Response to Bechtel Assertions Regarding Potential for Cooling Tower Recirculation at Southern Location (Parking Areas)

Bill Powers, P.E.
December 16, 2013

**Figure A. Cooling Tower for 605 MW Vermont Yankee Nuclear Plant (One Unit),
~1/2 Tower Length Separation Between Sections (SPX/Marley recommended separation is 1 tower length)**

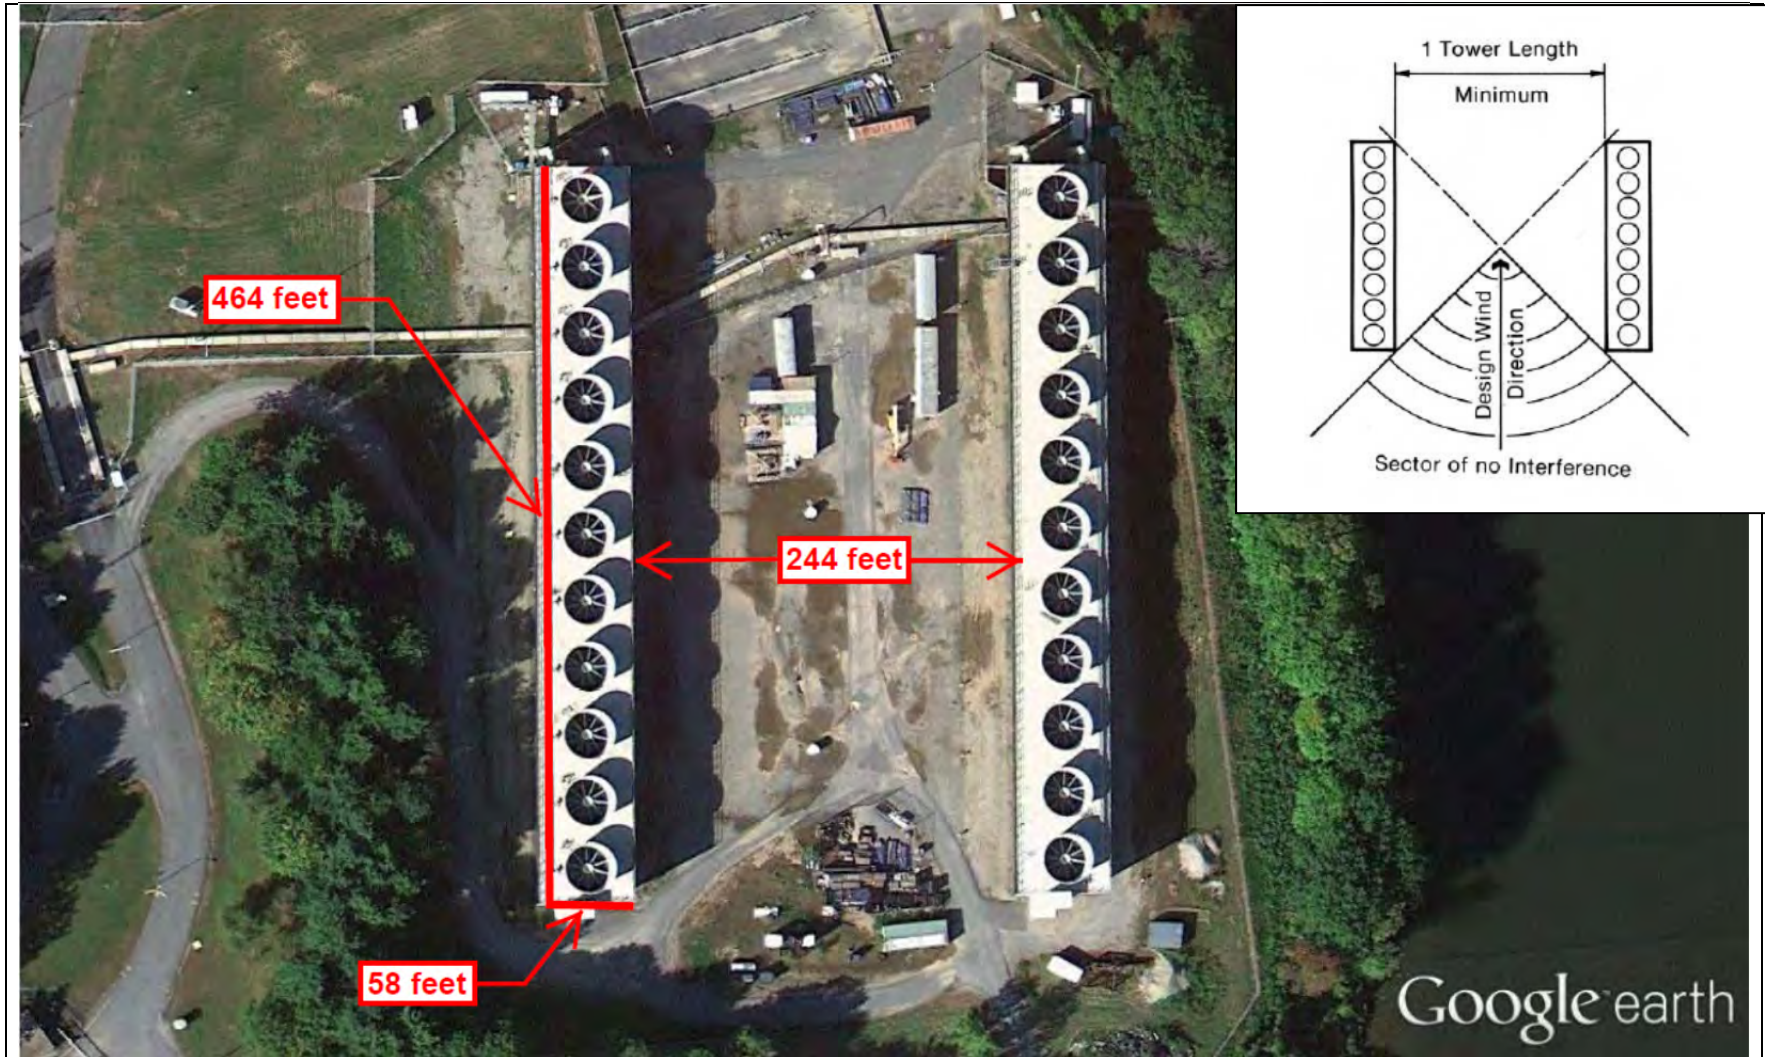
It is not uncommon for adjacent cooling tower sections to be placed more closely together than the minimum spacing manufacturers recommend to avoid significant recirculation and interference effects. See Figures A and B for two examples of closer spacing. Figure A is the cooling tower at the 605 MW Vermont Yankee Nuclear Plant. Figure B is the cooling tower for one of two 700 MW units at the Centralia (WA) coal-fired power plant.

Figure C. 30-Cell ClearSky Cooling Towers for Units 1 and 2, No Structure Removal Necessary

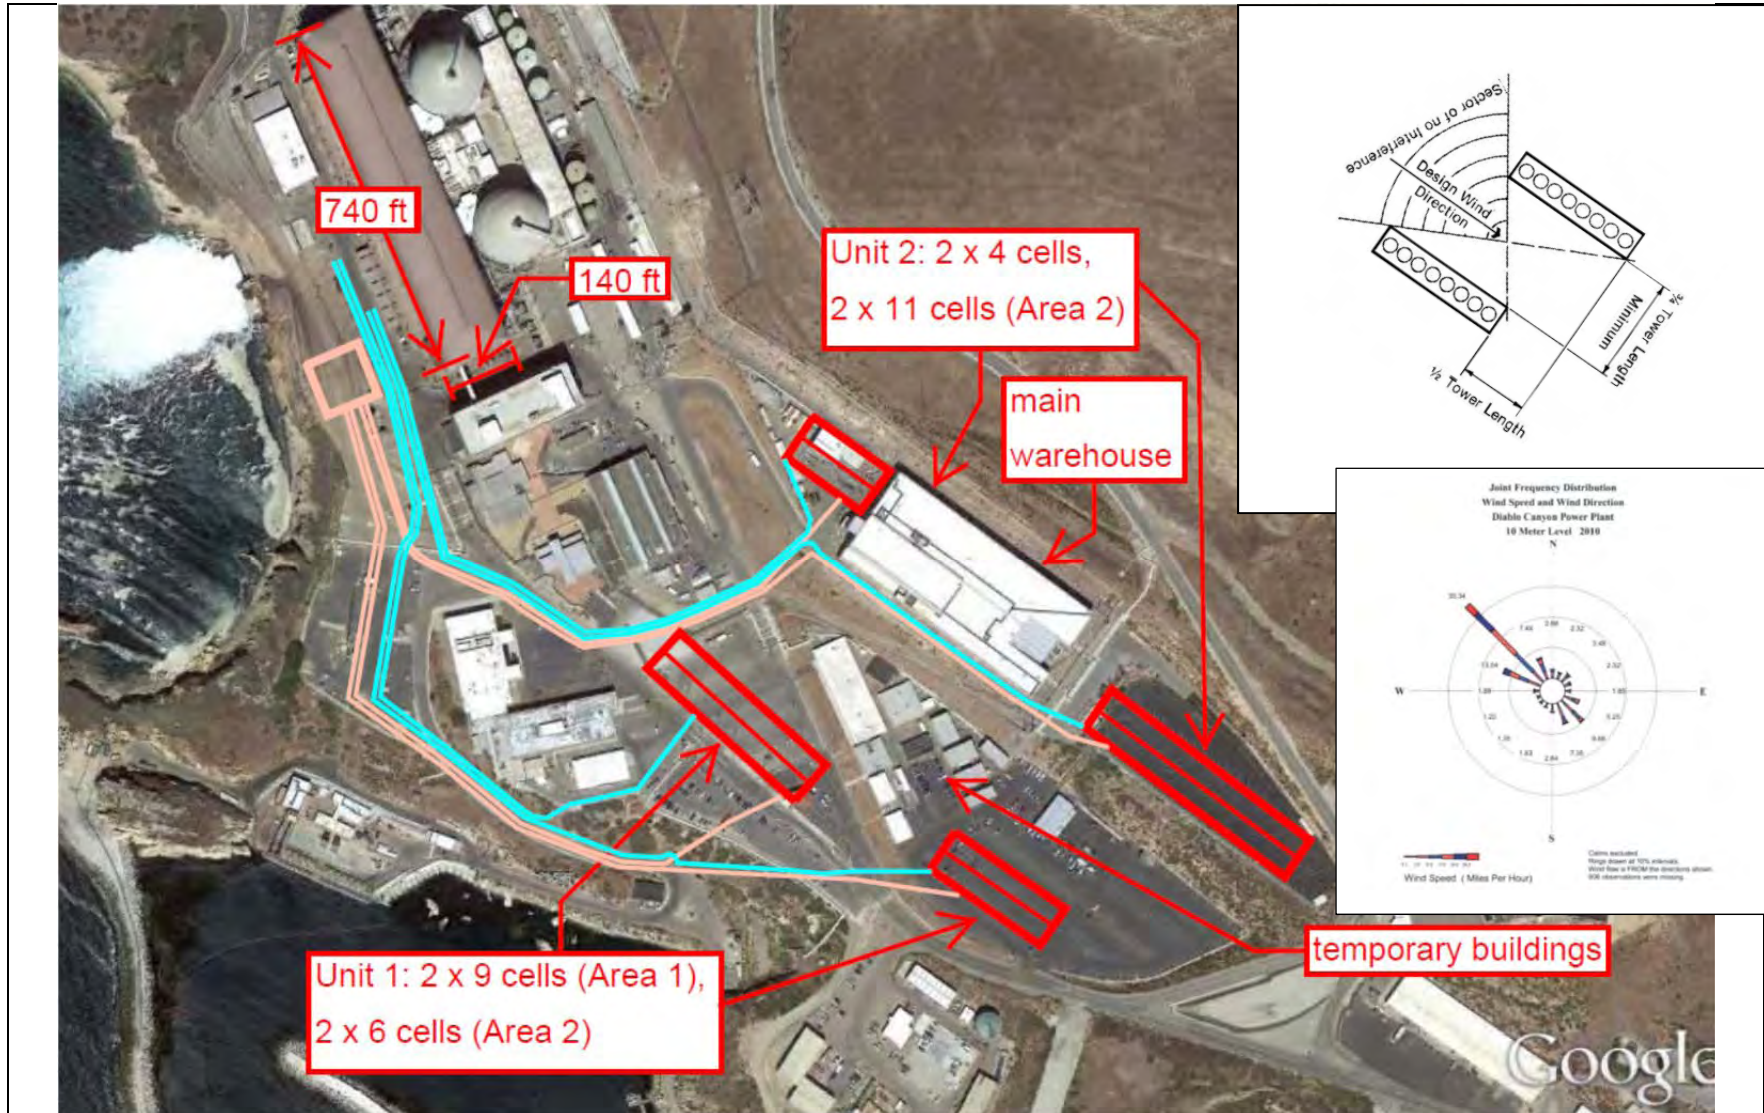
Attachment A to Bechtel's December 11, 2013 response is an excerpt from "Cooling Tower Institute Technical Sub-Committee #2 Report on the Study of Recirculation (PFM-110)." The excerpt used by Bechtel states "*Subsequent tests and additional data on cooling tower recirculation indicate that regardless of tower, size, type or configuration, the tower should be oriented so that the longitudinal axis of the tower should be parallel to the wind direction for minimum recirculation.*" That is exactly the situation for ClearSky™ linear cooling tower sections at the Diablo Canyon southern location. The tower sections would be parallel to the prevailing wind direction. This is shown in Figure 3 below, for 30-cell ClearSky™ cooling towers at the southern location. The 30-cell configuration has the advantage of avoiding any structure relocation.

Based on the SPX/Marley recommended spacing guidelines for cooling tower sections, minimal recirculation would be expected with the 30-cell ClearSky™ configurations shown in Figure C.
